Subject: New Push-In Style Speed Sensors

Document Number: TAIB0842

Date: November 19, 2012

New Sensor

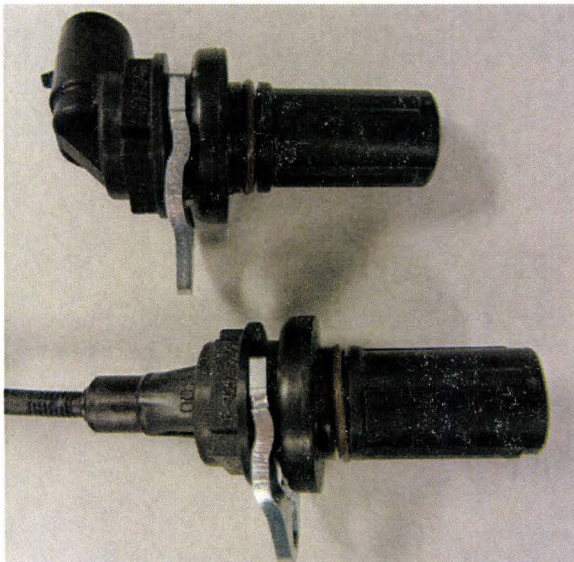
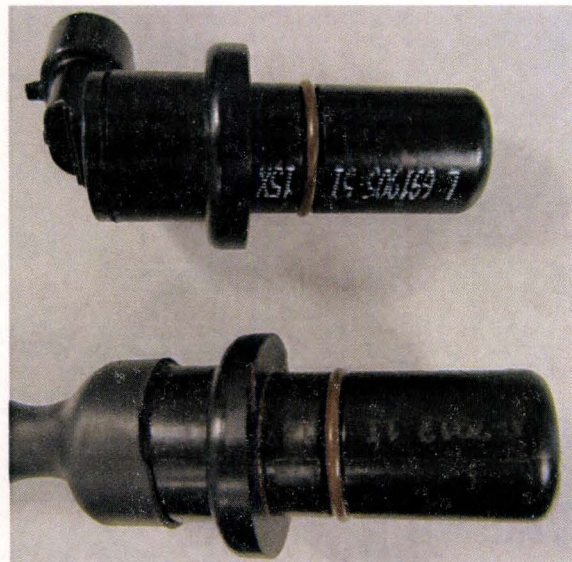
A redesigned speed sensor has been released into production and service. External changes include a sensor body designed to minimize corrosion seizing and integrated retaining clip that will not distort the sensor when the retaining cap screw is tightened. Sensor output signal, harness connector interface and 14142 O-ring are all interchangeable with current design sensors.

**X-8-460 – Input & Mainshaft Sensors
(MD output sensors)**

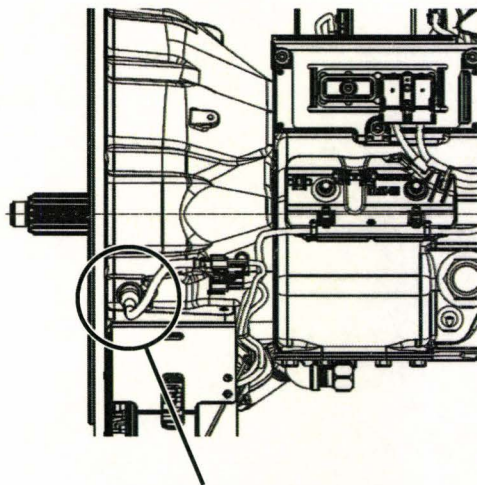
- Replaces X-8C-409 (0.250" - 20 x 0.625")
- Use E8 external Torx drive socket for installation
- Torque spec is 4-6 lbs. ft. (6-8 Nm)
